## Further Cleanpower NDM Questions to clarify number of STU's in Installation

**We need more information about your application**

**Application reference: EPR/FP3639ZD/A001**  
**Operator: Clean Power (UK) Limited**  
**Facility: Micheldever Energy Recovery Centre, Overton Road, Micheldever Station,  
Winchester, Hampshire, SO21 3AP**

**RE: CLEANPOWER (UK) LTD – Micheldever Energy Recovery Centre (EPR/FP3639ZD/A001)**

## APPENDIX 1: INTERNAL LAYOUT PLAN

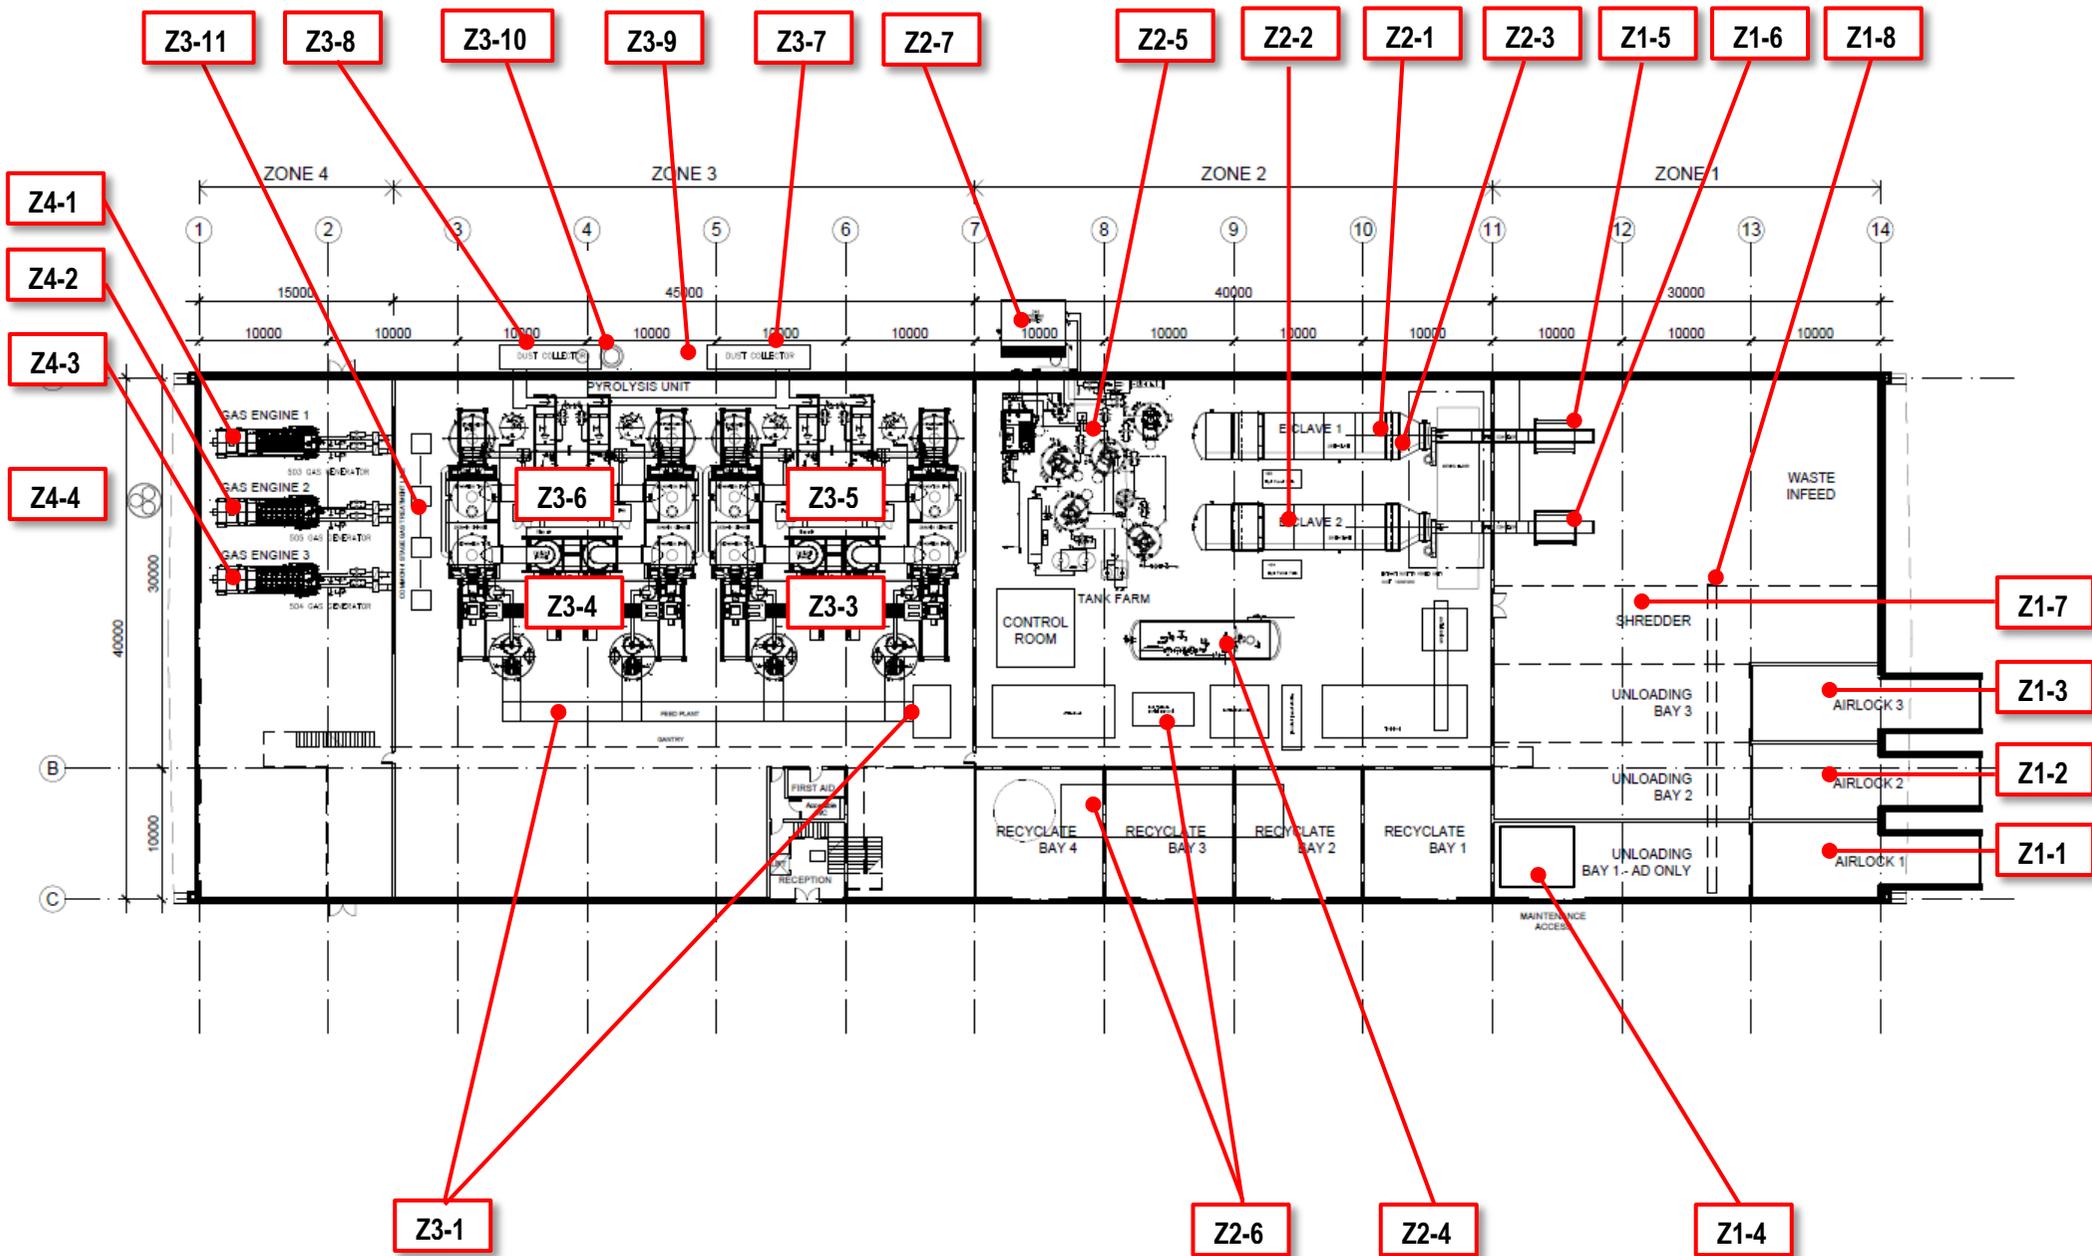
1. Please provide a revised site layout plan, confirming how many pieces of each item of equipment are employed. This should clearly show each functional piece of equipment from material feed to pyrolysis units, char discharge, char burners, HRSG and filtration. Also identify each part of the raw syngas clean-up plant, gas storage and spark ignition engines. The revised plan and an accompanying description should provide further details of the treatment/processing of the waste which is output from the autoclave units prior to its storage ready for input to the pyrolysis retort vessels.

*1. Please provide a revised site layout plan, confirming how many pieces of each item of equipment are employed. This should clearly show each functional piece of equipment from material feed to pyrolysis units, char discharge, char burners, HRSG and filtration. Also identify each part of the raw syngas clean-up plant, gas storage and spark ignition engines.*

*The revised plan and an accompanying description should provide further details of the treatment/processing of the waste which is output from the autoclave units prior to its storage ready for input to the pyrolysis retort vessels.*

The table below provides an overview of the key functional equipment located on site. This table should be read in conjunction with the updated site figure (Appendix 1). Please note that this plan does not include all minor plant, conveyor plant, duct work and internal tanks hoppers but does provide the key layout information of the main plant components and major ancillaries.

We can confirm that all recovered 'biofibre' is stored in a common storage and the fed via a common feed system to the individual retort feed screws. The location of the fibre feed systems is provided within the updated site figure.
